PLANNED UNIT DEVELOPMENT & SUBDIVISION STAFF REPORT

DEVELOPMENT NAME Government Street Subdivision, John Sims Addition to

LOCATION 1109 Government Street and 1108 & 1110 Church Street

SITE PLAN

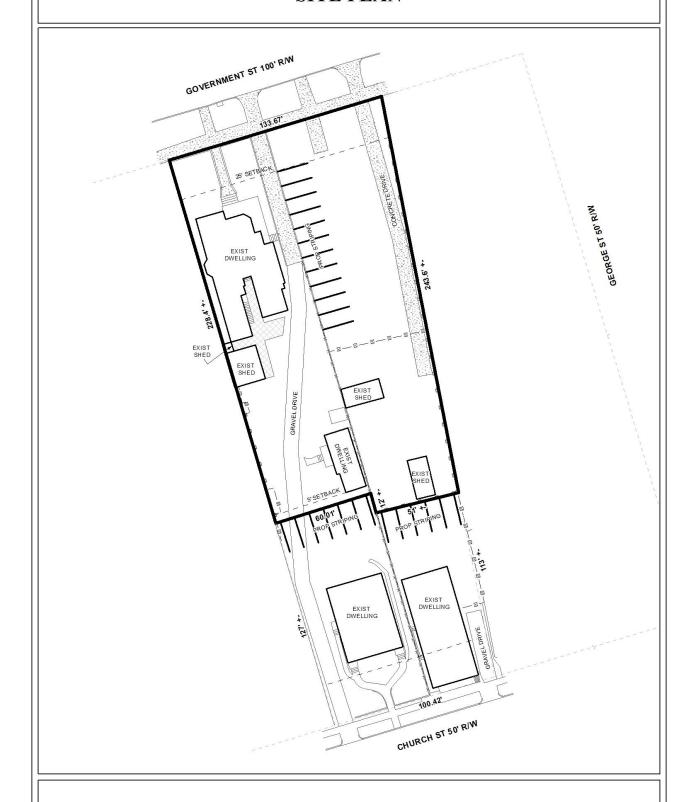
It should be pointed out that the site plan depicts a "gravel drive" or what would be considered an access road that crosses both Lot 1 and 2. If the intent is to have the "gravel drive" to remain, a revised PUD application will be required to include cross access between Lots 1 and 2. If the drive is to no longer be utilized, a revised site plan removing illustration of the shared access across both properties will be required.

A sidewalk is depicted on the site plan and should be retained on the site plan.

- 1) revision of the site plan to remove the illustration of the "gravel drive" shared access driveway across both Lots 1 and 2, or revise the PUD application to include Lot 2 as a part of the PUD request for shared access;
